## **Central Planning Authority**

**Agenda** for a meeting of the Central Planning Authority to be held on **October 13, 2021 at 10:00am, in Conference Room 1038, 1<sup>st</sup> Floor, Government Administration Building, Elgin Avenue.**

**CPA/21/21**

Figure 1: DOE's 2013 Habitat Map Extract showing application site (outlined in blue)

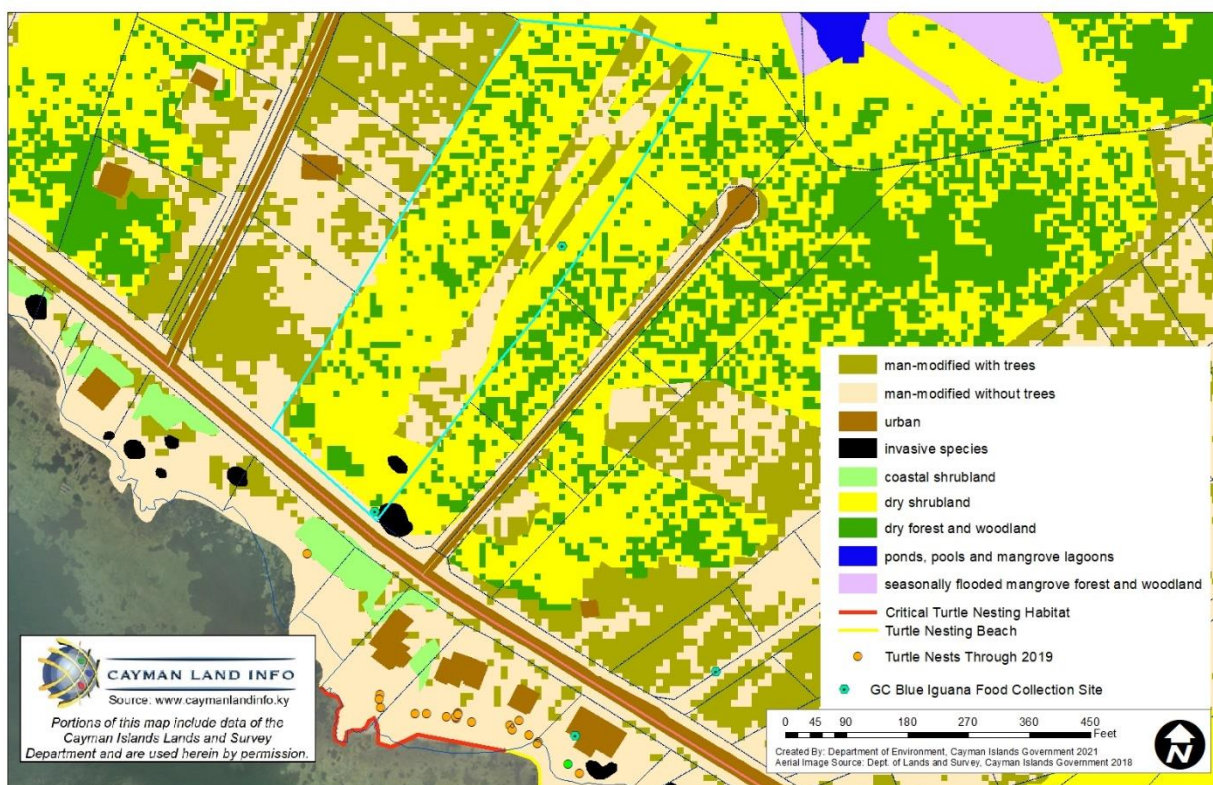
*The application site consists primarily of dry shrubland and forest with some limited areas that have been man-modified (See Figure 1), but has regrown with valuable secondary growth as shown in Figure 2. There are two locations on the parcel where food for the Blue Iguana Recovery Programme is collected by Blue Iguana Conservation staff (formerly Blue Iguana Recovery Programme). In addition, the site is located to the north-west an area designated as critical habitat for nesting sea turtles as defined in the Interim Directive*

for Green turtles, (*Chelonia mydas*), Loggerhead turtles (*Caretta caretta*), Hawksbill turtles (*Eretmochelys imbricata*) and all other species that may occur in Cayman Waters.

- *Retain native vegetation where possible and incorporate it into the landscaping scheme as native vegetation is best suited to the site conditions and is a cost effective option.*
- *A vegetated buffer strip should be left between the development access road and the eastern boundary to allow for the retention of Blue Iguana Recovery Programme food collection sites on the parcel. This vegetated buffer would also provide some privacy between the development and the adjacent parcels*
- *The natural ridge on site should remain as is. There shall be no excavation or mining of the ridge.*
- *The applicant should not include any floodlights or spotlights which are directed towards the turtle nesting beach.*

Figure 3: Plan Extract Overlaid onto LIS 2018 Aerial Imagery showing location of Iguana Food Collection sites (Blue Dots) (Plan source: Jay Welcome March 2021; Aerial Imagery, Lands and Survey Department, 2018)

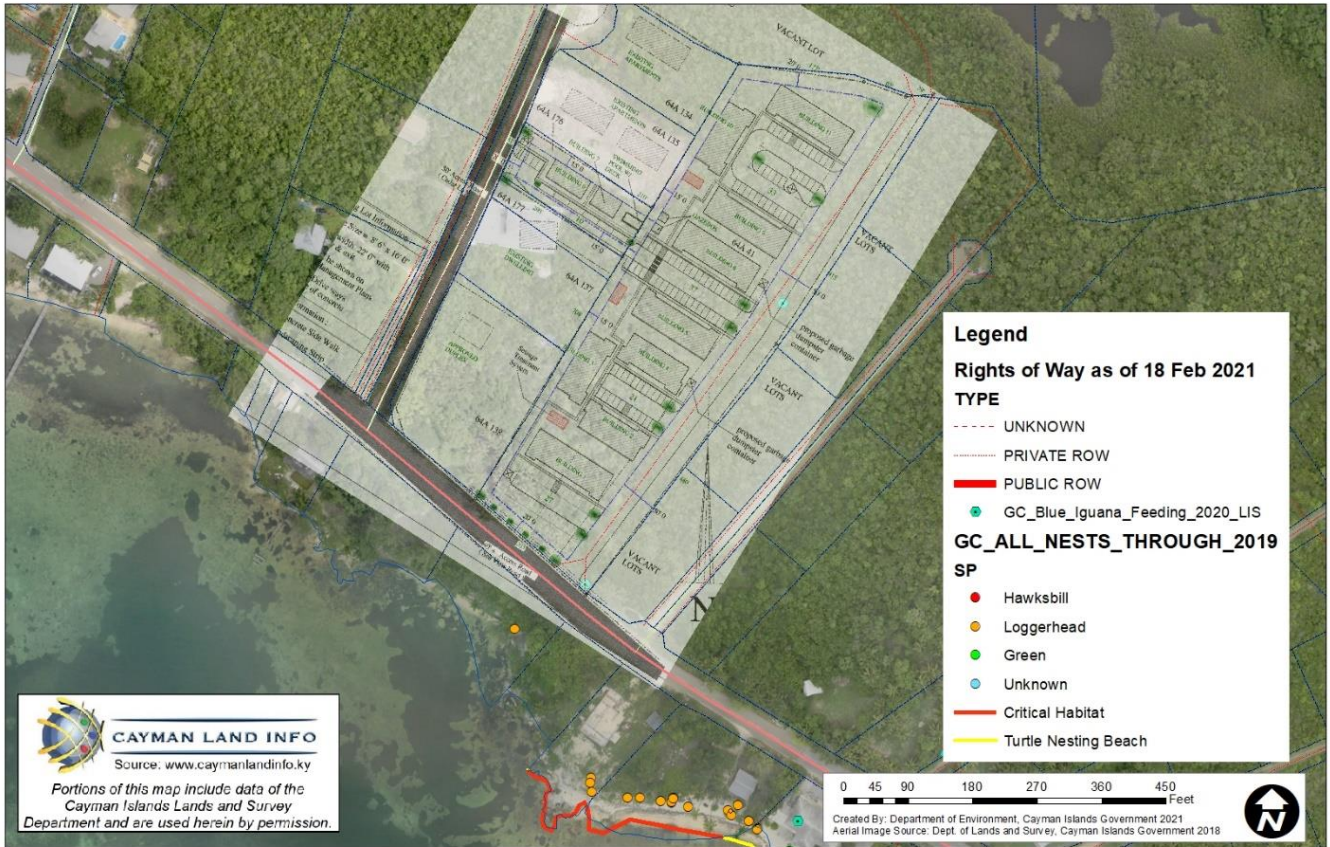
*The application site has two locations where Blue Iguana food is collected. These collections spots are on the eastern boundary and east of the proposed development access road as shown in Figure 3. The DoE recommends that the vegetation along the road is retained to allow for the food collection sites to remain. This strip could also act a vegetated buffer between the development and the adjacent parcels.*

*Figure 4: Showing LIS Terrain Model of the application site's (outlined in blue) ridge  
(Source:Lands and Survey Department)*

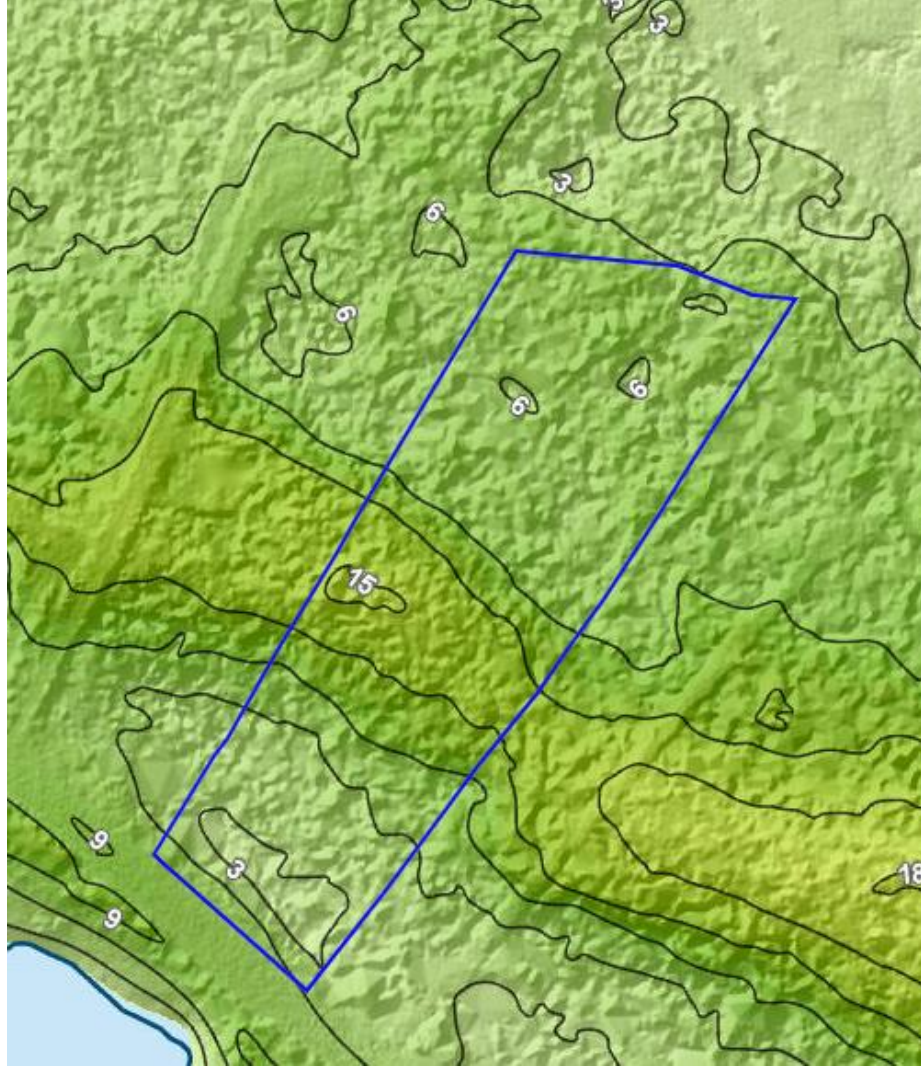
The terrain model as provided by the Lands and Survey Department (see Figure 4 and 5), indicates that there is a ridge in the center of the parcel that goes up to approximately 15 feet above mean sea level. The Department does not support any excavation or mining of the ridge. This geological feature of the site should remain and to be incorporated into the design of the development. It will assist with the resilience of the development to the ioacts of climate change, including storm surge.

Figure 1. The habitat present at the site (outlined in light blue), indicating mangroves along the southern boundary.

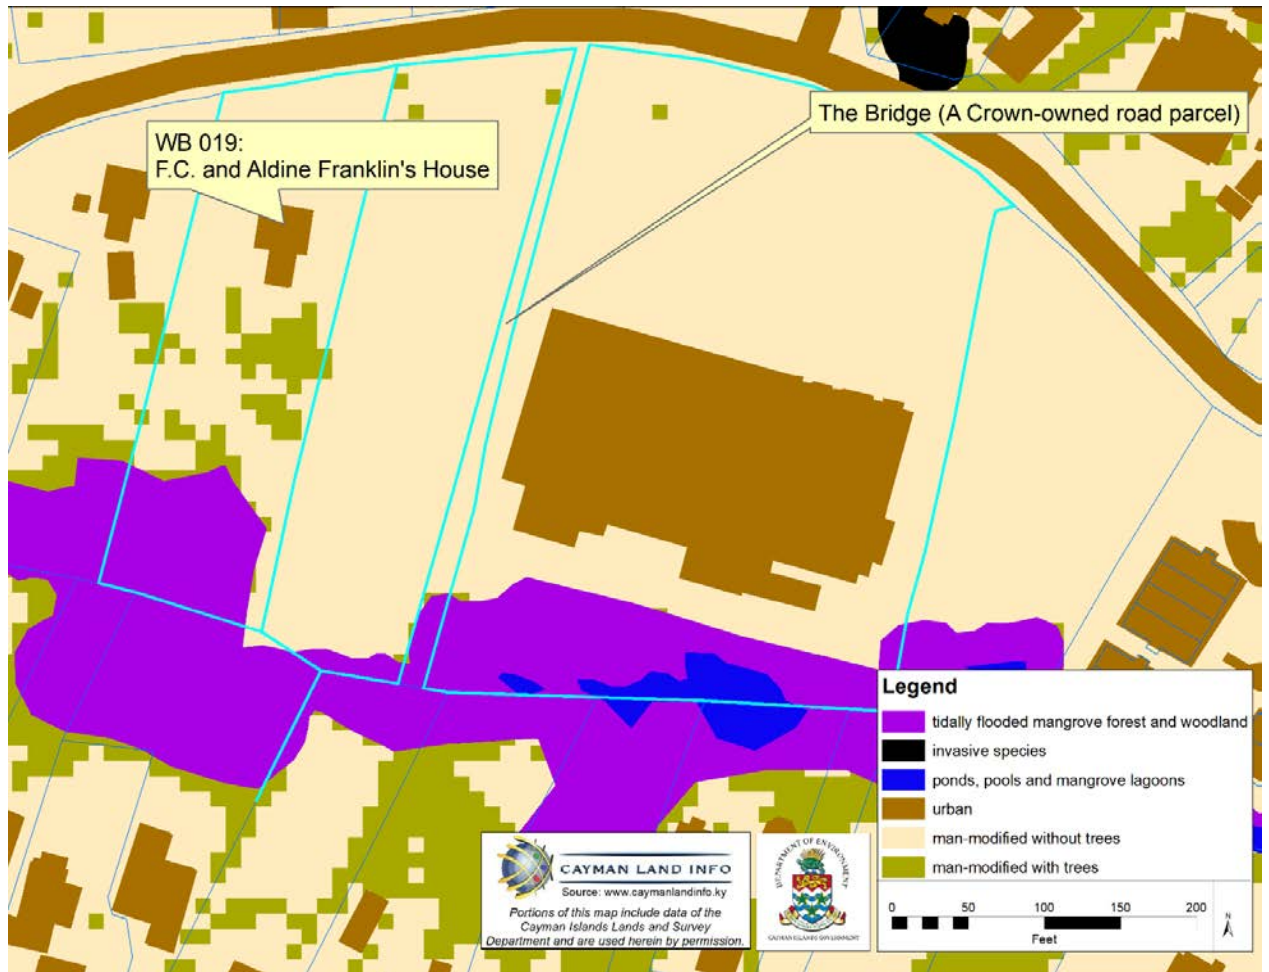
*There is primary habitat along the southern boundary of the site, which is seasonally flooded mangrove forest (see Figure 1). Mangroves are a Schedule 1 Part 2 Protected Species under the National Conservation Act 2013 and there is an adopted Mangrove Conservation Plan (2020).*

*We recommend the retention of mangroves where possible. We note that the Applicant is proposing to keep the mangroves behind the existing supermarket, but is proposing to clear, fill and use the area of mangroves to the west, however the purpose is not outlined on the map – it may be recycling or storage. It is recommended that this area be retained as mangroves, which can also assist with drainage. As shown in Figures 5 to 8, the area with the existing mangroves is low-lying and is likely providing stormwater drainage for the area.*

- The plans be modified to preserve the mangroves in the southwestern corner of the site,*
- The plans are revised to retain F.C. and Aldine Franklin's house in situ,*
- Further research into the boardwalk and trail is conducted by the National Trust, and*
- The plans are revised to protect or conserve the Bridge as agreed pending further discussion.*

*Figure 8. The Bridge is still visible as recently as the 2004 aerial imagery. In the 2008 Aerial imagery, the Bridge has been demolished as part of the previous expansion of the Foster's supermarket.*

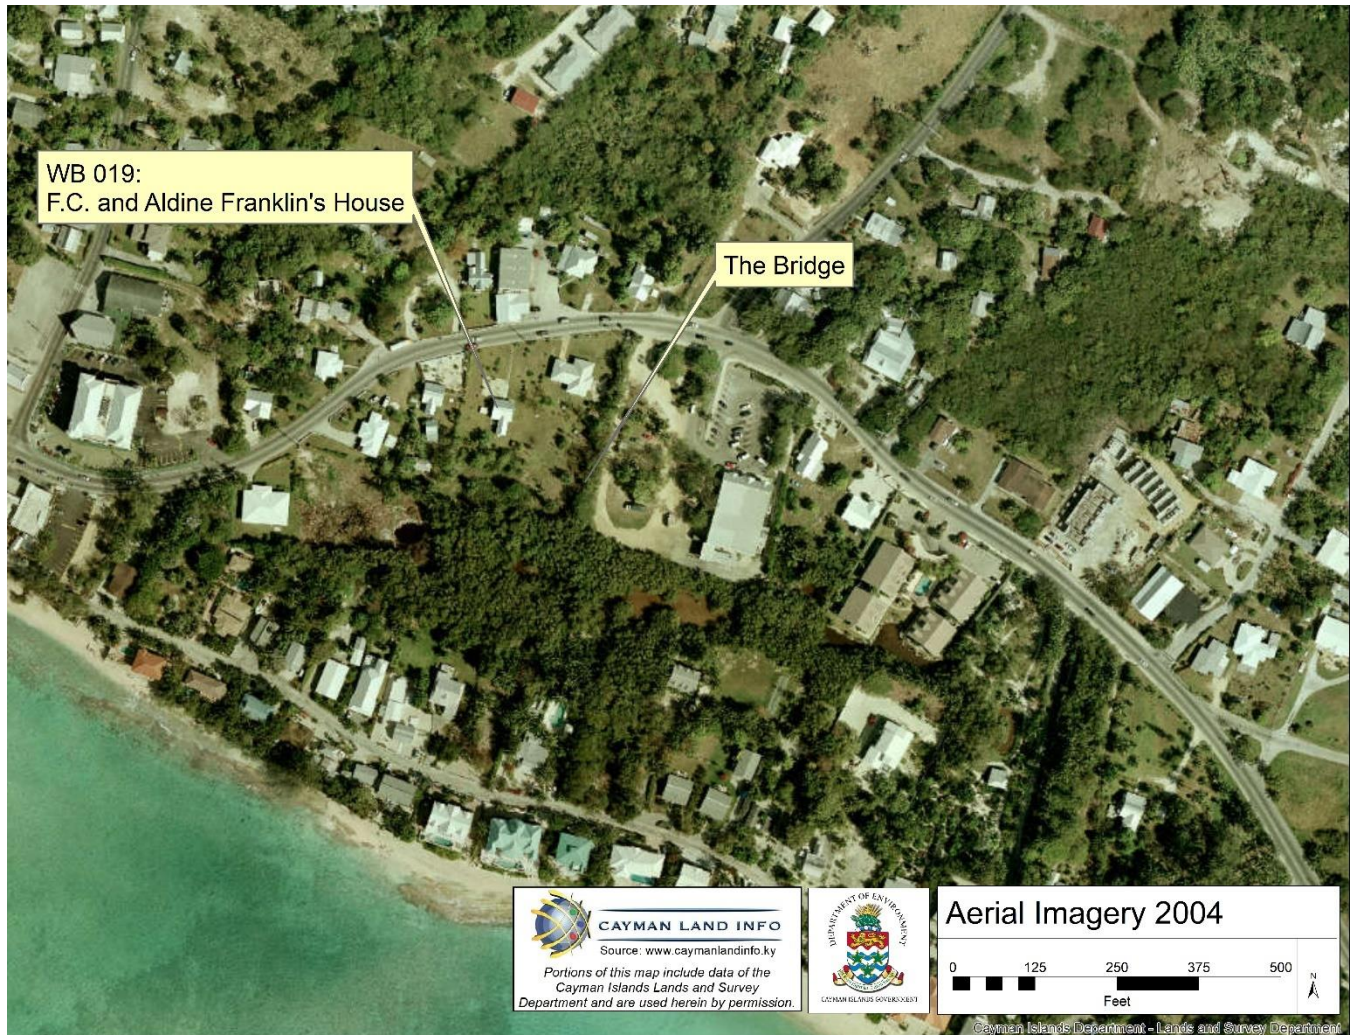
*In 2013, the Bridge is no longer visible, and is now part of the parking lot and a grassy area for the Foster's supermarket, even though the parcel is still registered as a public road. The expansion proposed would place the buildings of the supermarket over the public road. Currently, very little evidence of the Bridge is present (see Figure 9).*

Figure 1: DOE's 2013 Habitat Map Extract showing Application Parcel Outlined in Blue  
 Retaining vegetation can provide benefits to the property owner and the surrounding area, including:

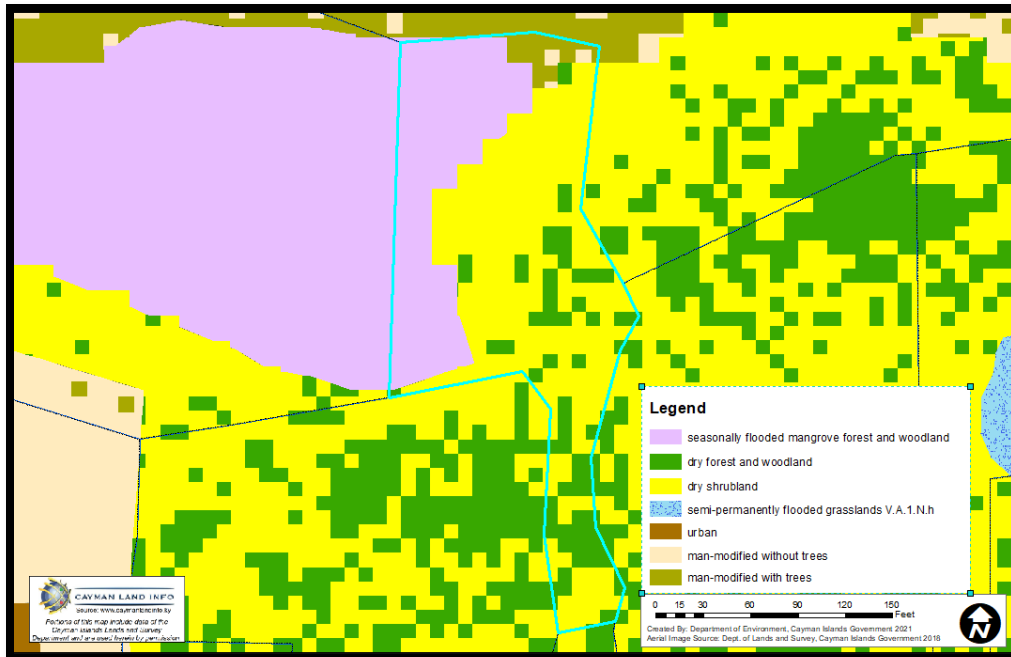
*The Applicant proposes to clear primary habitat, namely dry shrubland, dry forest and seasonally flooded mangrove forest and woodland. There is no justification provided from the applicant, and there is no development proposed to justify the loss of primary habitat. Clearing this site in the absence of an approved development or use, is considered to be speculative clearing which is not a practice that the DoE supports. Speculative land clearing removes the option of retaining native vegetation outside the footprint of a prospective development. It also results in the fragmentation of undisturbed primary habitat in the surrounding area. It is important to note that fragmentation is continuing to affect primary habitat interrupting important ecological services, wildlife corridors and facilitating the introduction of invasive species on cleared land.*

*Figure 1. The habitat present at the site.*

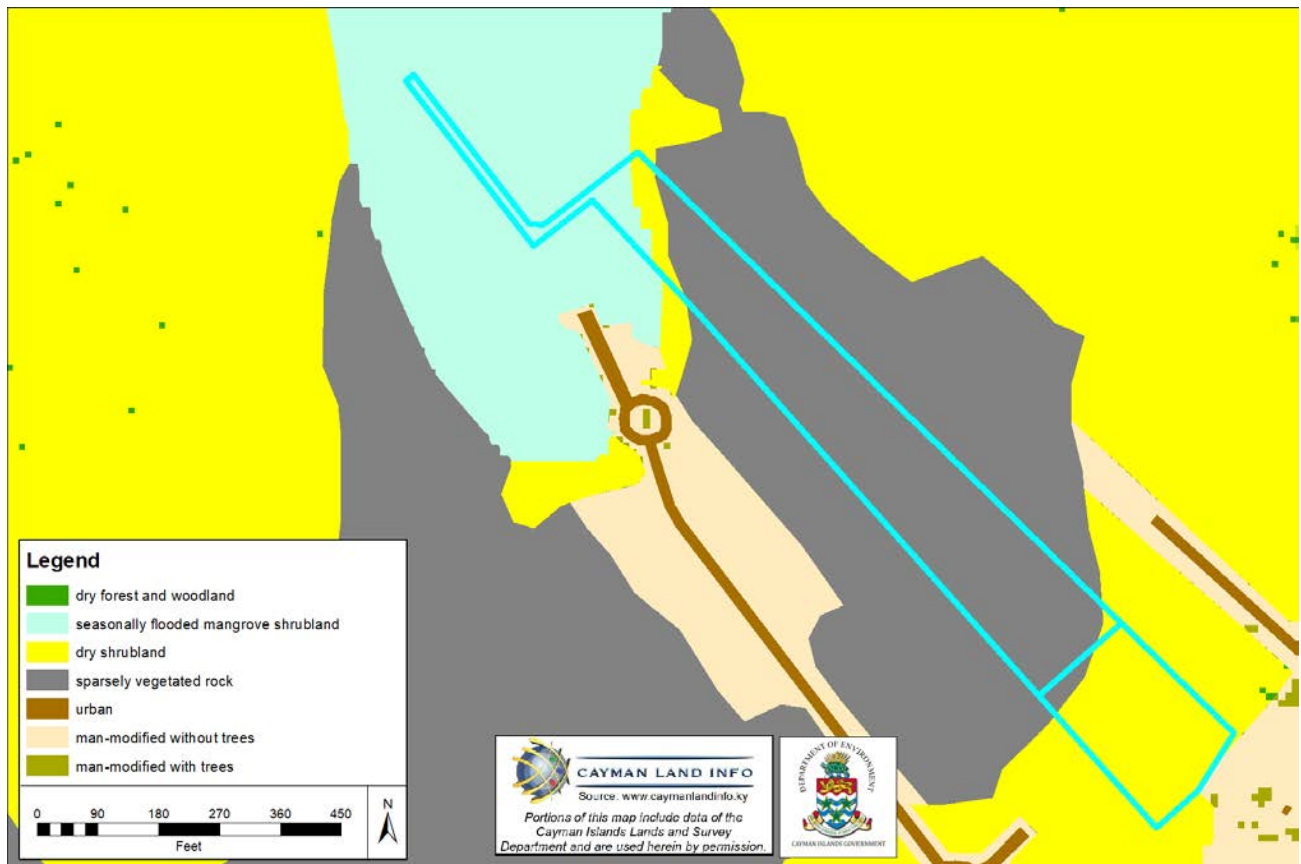
*The site is primary habitat, occupied by dry forest and shrubland in the south, sparsely vegetated rock in the central area and some seasonally flooded mangrove shrubland to the north, as shown in Figure 1. The site is very low-lying, lower than the road and development to the south. The low elevation is likely one of the reasons for the lack of vegetation in the central area.*

*Therefore, if the Central Planning Authority is minded to approve this application, we recommend the following:*

*Figure 1. The habitat present at the site.*

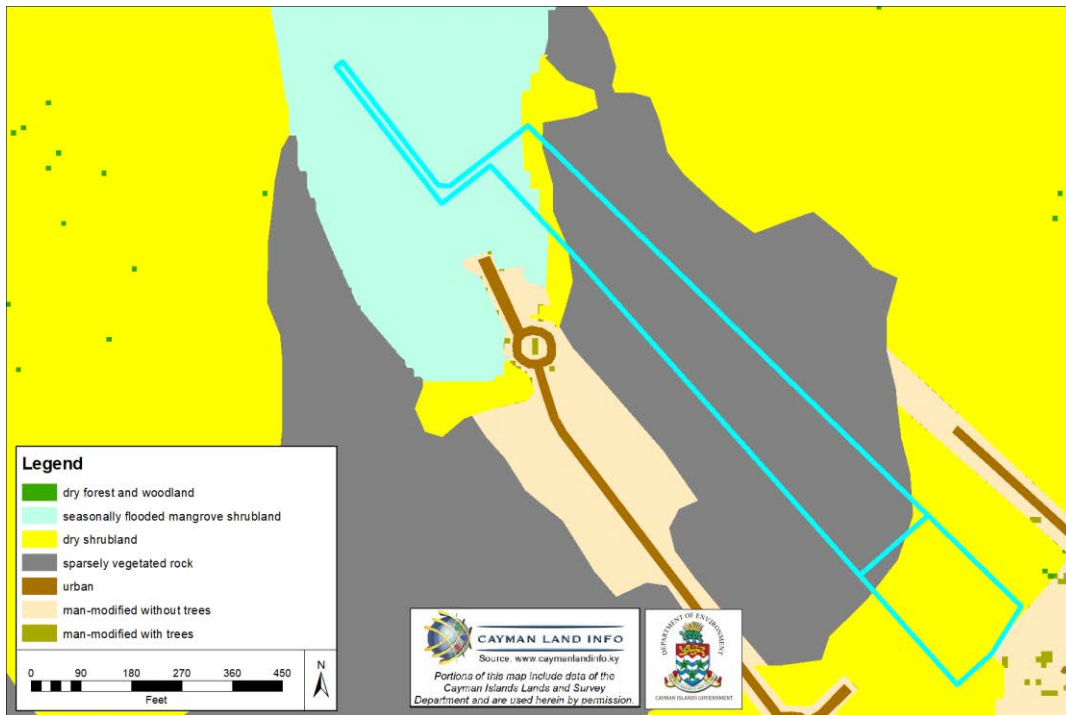
The site is primary habitat, occupied by dry forest and shrubland in the south, sparsely vegetated rock in the central area and some seasonally flooded mangrove shrubland to the north, as shown in Figure 1. The site is very low-lying, lower than the road and development to the south. The low elevation is likely one of the reasons for the lack of vegetation in the central area.

Therefore, if the Central Planning Authority is minded to approve this application, we recommend the following:

**Figure 3: DoE drone image from March 2019 showing the anoxic black/grey sediment nearshore.**

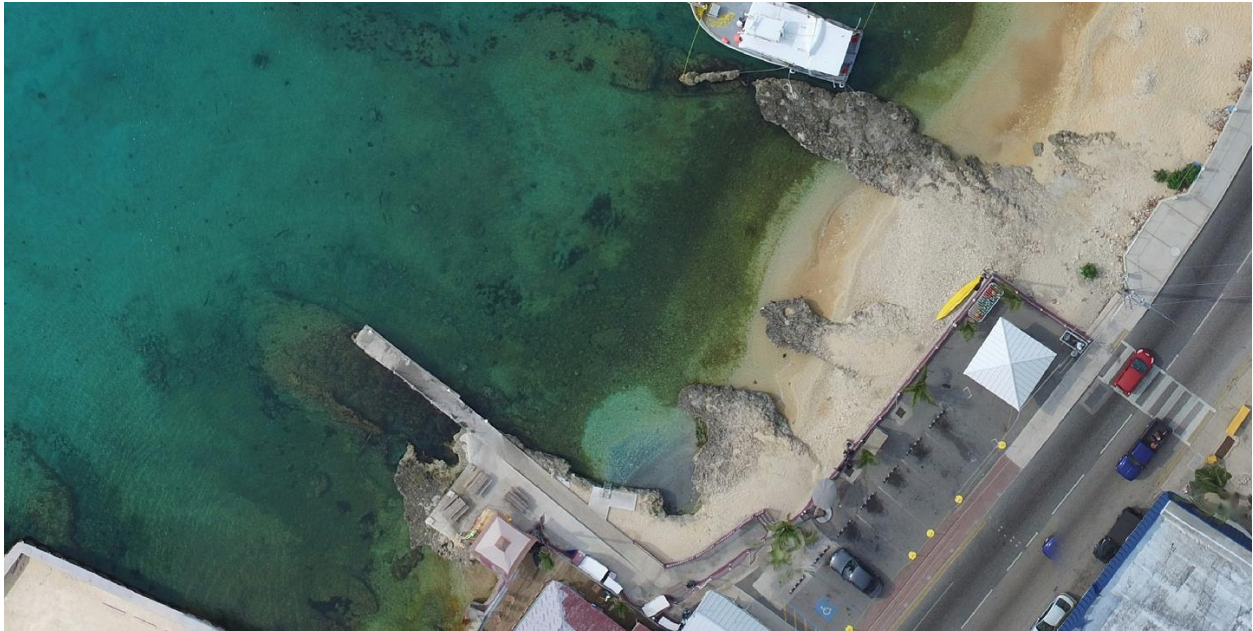
The cumulative effect of the ongoing unauthorised placement of construction sand and other unconsolidated material (including the fill material that is the subject of this application) into and adjoining the marine environment, together with the proximity to the local fish market (where regular fish cleaning results in increased nutrient loading and subsequent marine algal growth in the nearshore environment) is creating negative impacts on water quality. This is evident from the nearshore sediments and beach in the area which are often black or grey in colour with a strong odour exhibiting the anoxic characteristics of a highly disturbed environment (see Figures 3 & 4).
